## DELEGATED PLANNING REPORT

**7-9 NICHOLSON COURT, CLAYTON  
CONSTRUCT A FIVE STOREY APARTMENT BUILDING WITHIN A SPECIAL  
BUILDING OVERLAY  
(TPA/53913)**

***Extract of Clayton Activity Centre Built Form Plan***

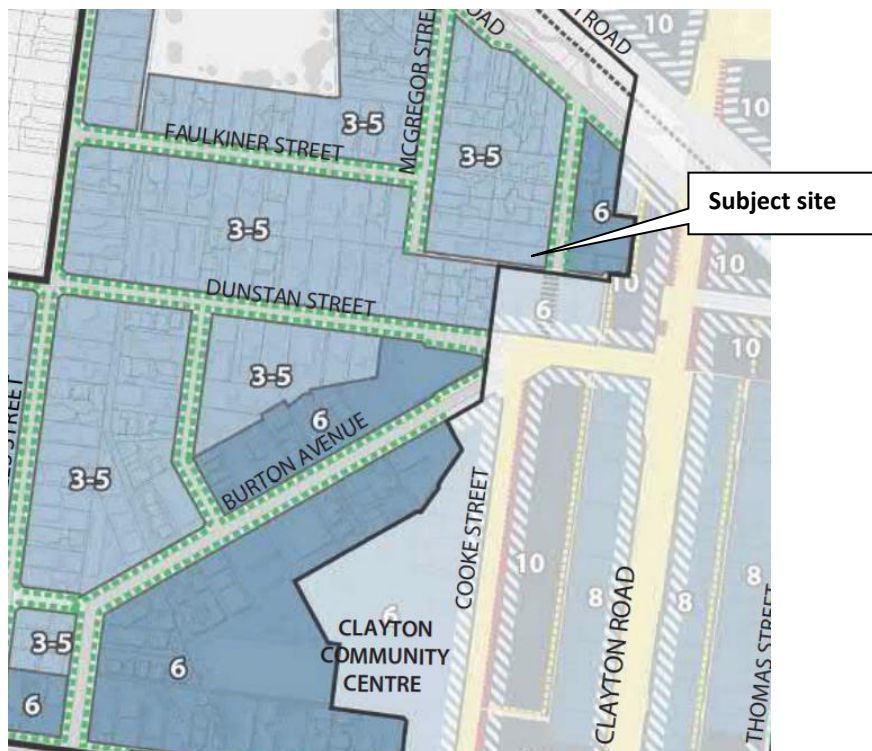
The proposed rear setback of 13.65 metres from the boundary for the fifth floor would satisfy the required setback of 9.9m. The Plan also provides for a height of between 5- 6 storeys for a property with a frontage greater than 30 metres. The development site has a frontage of 30.48 metres making a proposed development of 5 storeys possible under the strategy.

<b>Precinct Plan Setbacks</b>	<b>Assessment</b>
<b>Front setback</b>	4 metres landscape setback from the street for developments up to 9.9 metres. 3 metres additional upper level setback for development above 9.9 metres.	<b>Variation sought</b> The building has front setback of 4 metres for 3 storeys and complies. Fourth floor setback of 6 metres (with balconies encroaching) does not comply and should be 7 metres.

<p><b>Rear Setback</b></p>	<p>3 metres rear setback for development up to 9.9 metres, plus 1 metre additional setback for every meter of height over 9.9 metres up to 16.5 metres.</p>	<p><b>Variation sought</b> Minimum ground floor setback of 2.5 metres does not comply but 3 metres complies for first and second floors up to height of 9.9m. Fourth and fifth floors comply</p>
<p><b>Side setback</b></p>	<p>1 metre setback, plus 0.3 metres for every metre of height over 3.6 metres up to 9.9 metres, plus 1 metre for every metre of height over 9.9 metres, up to 16.5 metres</p>	<p><b>Variation sought</b> Fifth floor balcony setback 8.28 metres from northern boundary and setback of 9.6 metres required.</p>
